# BMW Motorrad USA

## Service Information Bulletin

**Subject: Recall 05V-363: Change to the routing of the front I-ABS sensor cable.**

**Model: K 1200 S (K40), K 1200 R (K43)**

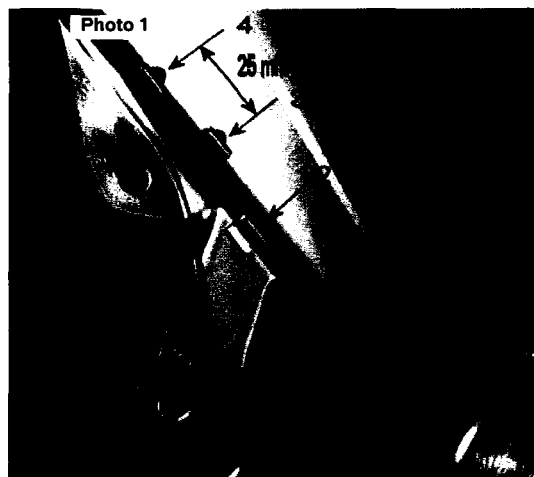
**Details:** When disassembly work, such as a tire change, is being carried out, there is the possibility of the I-ABS sensor cable sagging into a loop in the vicinity of the left front brake caliper

With the sensor cable in this position there exists the possibility of the cable chafing against the brake disc. If this were to happen a malfunction of the sensor would make the ABS function unavailable to the rider.

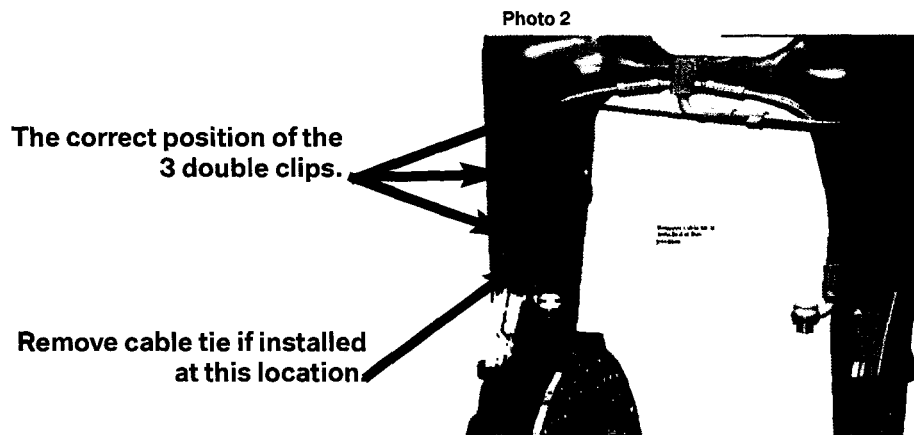
**Production Solution, revised information:** In motorcycles from series production there will only be three (3) retaining clips. Starting with the VINs noted below, clip #3 for the sensor cable on the wheel carrier has been moved up 25 mm to position #4 as shown in Photo 1. The total distance between the first and third clips on production motorcycles is now 123 mm, the same as the distance between the first and forth clips on motorcycles modified as a result of this recall.

Check to see if the distance between the first and the third retaining clips is 123 mm. If this is the spacing, all that remains is to check that the sensor cable is correctly secured to the brake line.

If the distance between clip #1 and clip #3 is 98 mm, you must follow the points detailed in "Procedure" described below, drilling a hole in the wheel carrier to accept the additional clip.

- 1) Remove the front wheel as described in the repair manual.
- 2) Remove the I-ABS sensor.
- 3) Use a center punch to mark the wheel carrier at a point on the radius 25 mm above point #3 in photo #1.
- 4) Drill a 4mm diameter hole into the wheel carrier.
- 5) Seat the locating spring clip into the 4mm hole.
- 6) Secure the sensor cable in the new locating spring clip.

**An important point that applies to all motorcycles:** Always be sure to check the other sensor cable retainers. The sensor cable must follow, and be attached to, the brake line by three double clips as seen in photo #2. Make sure that the double clips are positioned as shown in photo #2.

If you find a cable tie securing the ABS sensor cable to the brake line fitting (see notation in Photo 2), remove this cable tie.
